Fig. 1 Outline schematic of a low noise differential input amplifier.

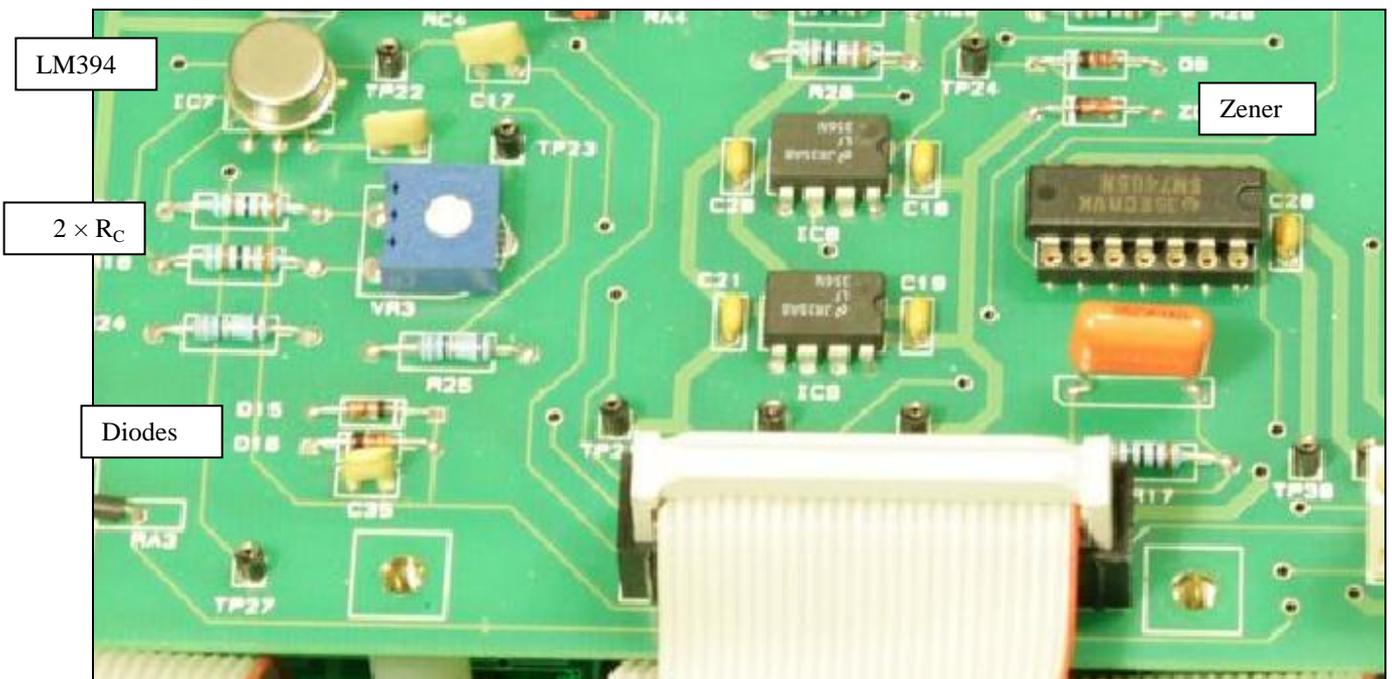
The design is a little unusual – instead of the usual high gain transistor (BC109) the constant current source is implemented with an op-amp and the 5V1 zener ref. The feedback operates so that 5.1V is dropped across each R_C .

I can't quite make out the values of R_C . I suspect 5k1 so that each transistor runs at 1mA (low voltage noise). The trimpot is to adjust DC offset and is probably 100 or 220 Ω .

R_F and R_E set the feedback factor: probably 10k and 10 Ω for a gain of 1000.

For a solid reference voltage the zener needs a greedy 5mA (ish) so I guess $R_Z \approx 2k$.

The "snubber" pairs (e.g. C17 and R25) reduce the open loop gain at high frequency, reverting to first order before passing through 0dB in order to ensure closed loop stability. See part 5 monograph 2 especially section 4.4.1.

Fig. 2 I am not impressed with the PCB layout. I must have words with the lads

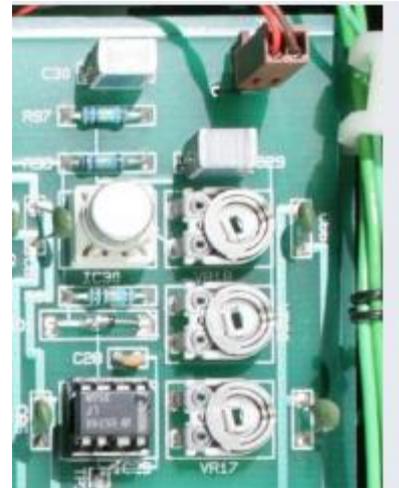
The pre-amp inputs operate at $\approx 0V$ (one is connected to the bridge virtual earth) so that common mode (and CMRR) is not critical. The main resistors can be 1% tolerance.

The back-back diodes protect the inputs and the small cap (C35) clobbers high frequency interference.

25Hz ripple is expected – the difference between 75Hz (operating frequency) and 50Hz or, more likely, 100Hz interference. The latter is probably due to the current pulses that charge the PSU smoothing caps (every half cycle) which, with poor wiring layout, transmits magnetic flux. Have a look at the error signal before the synchronous rectifier (before the CD4066 etc).

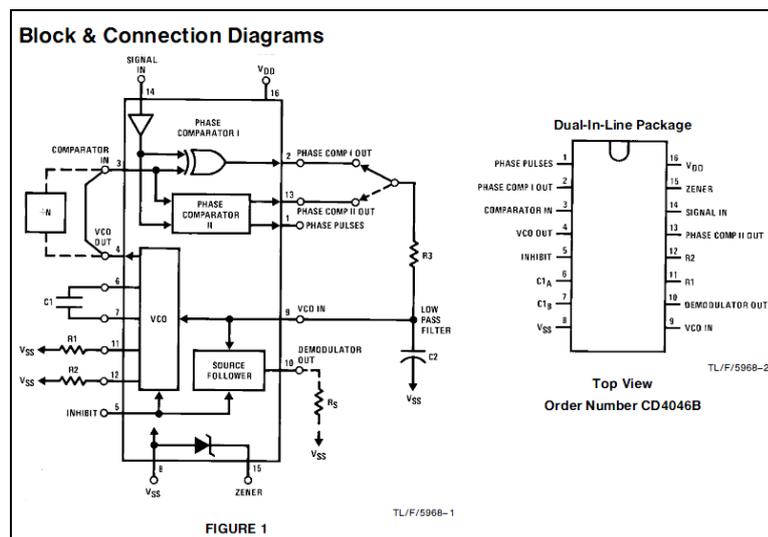
1). What is the metal can IC on the corner of the main analogue PCB?

2). There are two CD4046 phase lock loop chips. Could you please check the inputs (pin 14) and outputs (pin 4). I can understand one (recovers in-phase ref for the main synchronous rectifier) but, as far as I can remember there is no quadrature servo. Also it needs only one PLL to do both (running at 300Hz and divide by 4 using CD4013).

3). I guess that the AD 7525 BCD MDAC became obsolete, hence the bodge (module) on the F300.
